WEST VIRGINIA DEPT. OF TRANSPORTATION, DIVISION OF HIGHWAYS

SEPTEMBER 2017

**ADDENDUM TO THE
WV 601 JEFFERSON ROAD, US 119 TO US 60
JUNE 2016 ENVIRONMENTAL ASSESSMENT**

Figure 1. Preferred Alternative 5 and Area of Change since 2016

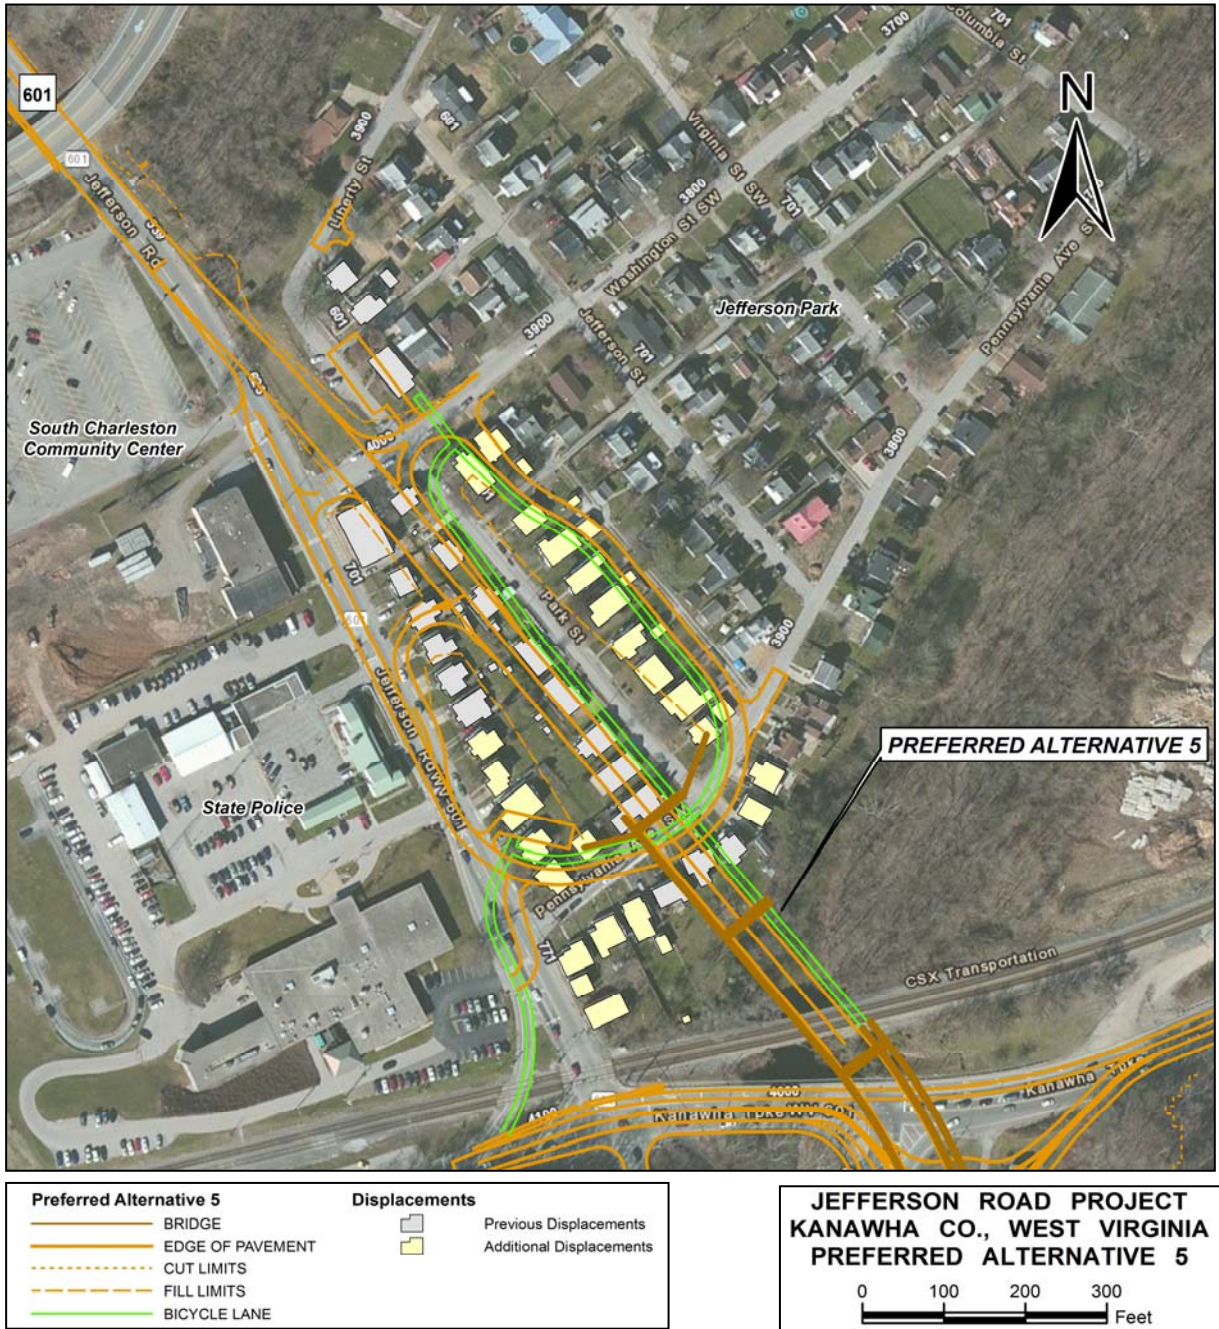
Since issuance of the EA in June of 2016, WVDOH adjusted the Preferred Alternative in response to comments received from the public and further consideration for the access points between the new road and the Jefferson Park neighborhood. For eight homes in Jefferson Park, 10 complaints were received about the wall that would support the bridge's ramp. The wall would change the views and suburban feel of Park Street. Residents also expressed concern for the delays in turning left from the Jefferson Park neighborhood onto Jefferson Road. While the 2016 Preferred Alternative 5 included the possibility of a traffic light to alleviate that concern, WVDOH reconsidered that option because of concern for the free flow of traffic coming off the bridge and for that location's proximity to the MacCorkle Avenue stoplight.

Therefore, WVDOH undertook additional design study to devise solutions to these issues. WVDOH revised the design to remove the wall by placing the ramp on fill and to incorporate a "right turn only" traffic pattern for vehicles accessing the new 5-lane Jefferson Road. With the fill design, the project footprint and certain impacts increase, but safety concerns are more thoroughly addressed. With the right turn only pattern for the Community Center and Jefferson Park exits, the need for a stop light that some commenters voiced is alleviated. Along with this change, the bicyclist/pedestrian pathway could be fit within the expanded right-of-way, which helps address concerns for connectivity and safety in crossing Jefferson Road. Each of these elements are described in greater detail below in the following sections.

- Eliminating the wall along Park Street;
- Expanding the right-of-way surrounding the ramp, which involves shifting Park Street to the east;
- Eliminating the traffic light at the northern end of bridge¹;
- Extending the shared use path to provide a loop through the Jefferson Park neighborhood and to connect directly to Kanawha Turnpike;
- Making the turning movements onto and off of new 5-lane Jefferson Road will be "right-turn-only" in this area; and,
- Relocating 21 additional residences (additional changes in impacts are addressed throughout Section 4.0).
